SERVICE BULLETIN

Flashing of a new Software on the Engine Control Unit 912 iS (ECU) for ROTAX® Engine Type 912 i (Series)

ATA System: 76-00-00 Engine control

MANDATORY

Fig. 1
Positioning of the ECU update label

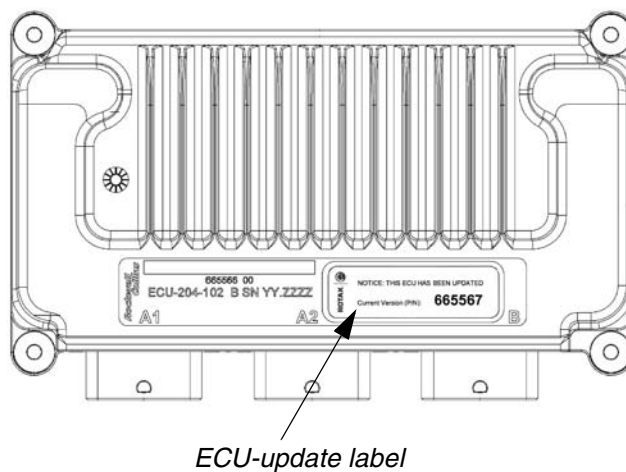
The ROTAX® authorized distributor or its Service Center must express that the software of the ECU has been flashed and the new part number of the ECU can be seen on the label. The positioning of the update label must match the location and orientation shown in Fig. 1. The label must not be removed.

The ROTAX® authorized distributor or its Service Center must attest that the software of the ECU has been flashed and the new part number of the ECU can be seen on the label. The positioning of the update label must match the location and orientation shown in Fig. 1. The label must not be removed.
